# Access Compliance Report

### (Curb Ramps)

Intersection ID: 29186	Main Street: AMUR_CT	Cross Street: JADE_GLEN_DR	Location: S
ADA ID: 7566831A8048	Ramp Type: PerpDiag	Initial Pass/Fail: Fail	Overall Compliance: No
Severity Score: 1.25			
Codes/Mitigation Info/Possible Solution		Field Measurements/Component Compliance

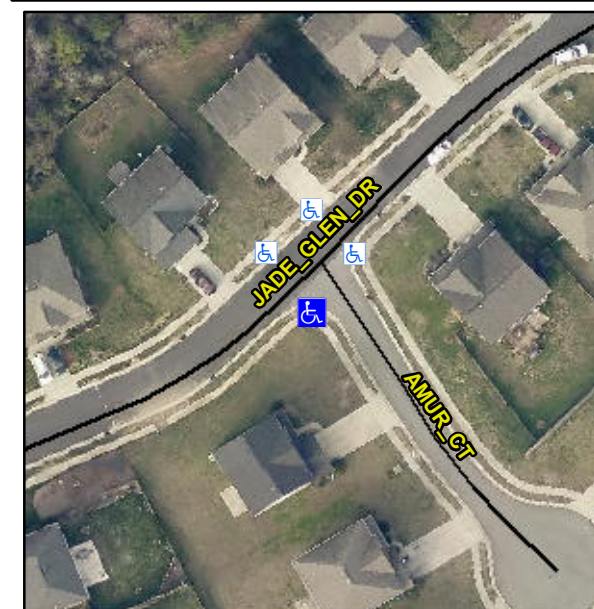
**Not Found, R304.5.3**

Compliance	Description	Data	Compliance	Description	Data
N/A	Ramp Length (in)	51.0	Yes	Ramp Slope (%)	6.8
Yes	Ramp Width (in)	48.0	No	Ramp XSlope (%)	5.0
N/A	Flare Type LT	N/A	N/A	Flare Type RT	N/A
N/A	Flare Slope LT (%)	N/A	N/A	Flare Slope RT (%)	N/A
N/A	Flare Traversable LT?	N/A	N/A	Flare Traversable RT?	N/A
N/A	Landing Length (in)	N/A	N/A	DWS Provided?	N/A
N/A	Landing Width (in)	N/A	N/A	DWS Contrast?	N/A
N/A	Landing Slope (%)	N/A	N/A	DWS Length (in)	N/A
N/A	Landing X Slope (%)	N/A	N/A	DWS Full Width?	N/A
N/A	Landing Curb? (Y/N)	N/A	N/A	DWS Offset (in)	N/A
N/A	Shared Landing?	N/A			
N/A	Gutter Ponding?	N/A	N/A	Gutter Slope (%)	N/A
N/A	Gutter Lip Ht (in)	N/A	N/A	Gutter X Slope (%)	N/A
N/A	Painted X Walk1?	No	N/A	Painted X Walk2?	No
	X Walk 1 Direction	To NE		X Walk 2 Direction	To NW
N/A	X Walk 1 Width (in)	N/A	N/A	X Walk 2 Width (in)	N/A
	X Walk 1 Slope (%)	4.0		X Walk 2 Slope (%)	1.7
	X Walk 1 X Slope (%)	5.8		X Walk 2 X Slope (%)	5.1

**Remove & Replace Curb Ramp With Two New Directional Ramps or Equivalent.**
